§Appl. No. 10/688,887
Amdt. dated September 14, 2005
Reply to Office Action of, April 14, 2005

In the Drawings:

REMARKS/ARGUMENTS

Exhibit

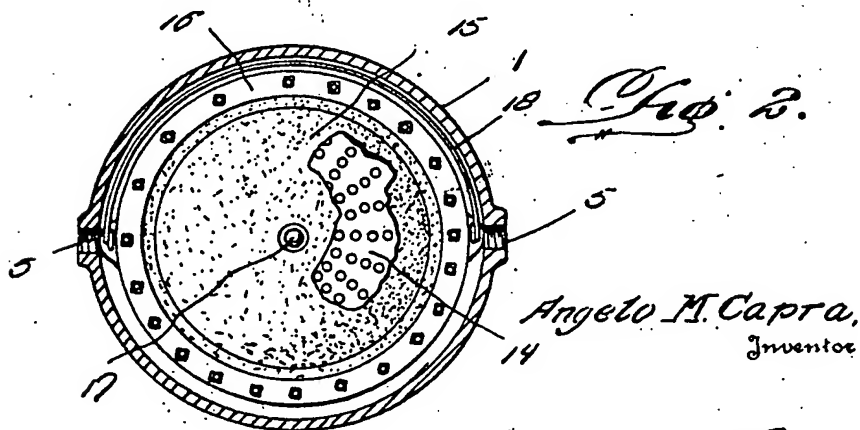
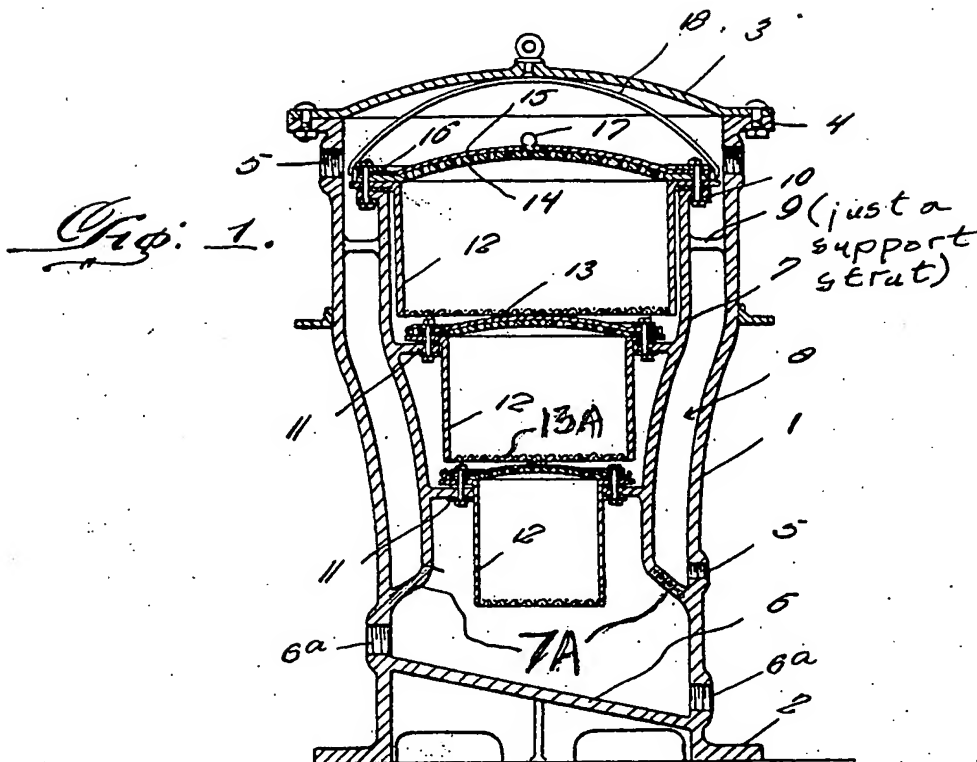
The only structure in Capra which could be considered analogous to Applicant's claimed baffle 30 is the lower flared end 70 of the supplemental wall 7 which is unitary with the vertically elongated casing 1 of Capra (see marked up attachment of Capra's drawing). This lower flared end 7A of Capra is below the second filter 13A. In Applicant's claimed invention as is set forth in claim 15, the baffle 30 is positioned above the secondary filter 40.
